17/02778/1DOC - Details reserved by Condition 6 (Construction Management Plan (CMP)) of Planning Permission Reference No. 15/01618/1 granted on 27 May 2016.

Land Adjacent To Elm Tree Farm, Hambridge Way, Pirton

Representations submitted on behalf of the Holwell Residents' Group, HACT

Is this an appropriate route for construction traffic

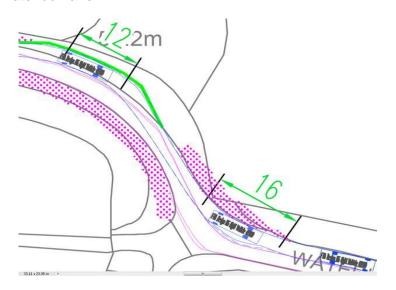
- introducing passing places, but not where needed. They are only provided where they can be accommodated within the highway boundary. As shown below, HGV's bound for the site would have to traverse across the whole road from Waterloo Lane and use the proposed lay-by on the opposite side for normal travel. Otherwise, they cannot negotiate the bend at all. How can this be deemed safe and effective in accordance with Condition 6.

I reproduce just one screen-shot from the Waterman Tracking Plan, which illustrates them justifying the blue lorry having to use the opposite side of the road, including the offside passing bay, in order to travel normally towards the site. All this is on a blind corner where the proposed vehicle-activated sign would warn, but not prioritise movement. The only safe answer is to introduce signalling to control the 2-way operation of a single track. Then, the waiting area at the signals will need to be wide enough for two large vehicles to pass each other. Even Waterman's plan, using opposing vehicles just 2.5m wide with no clearances, show this cannot be achieved on Waterloo Lane.
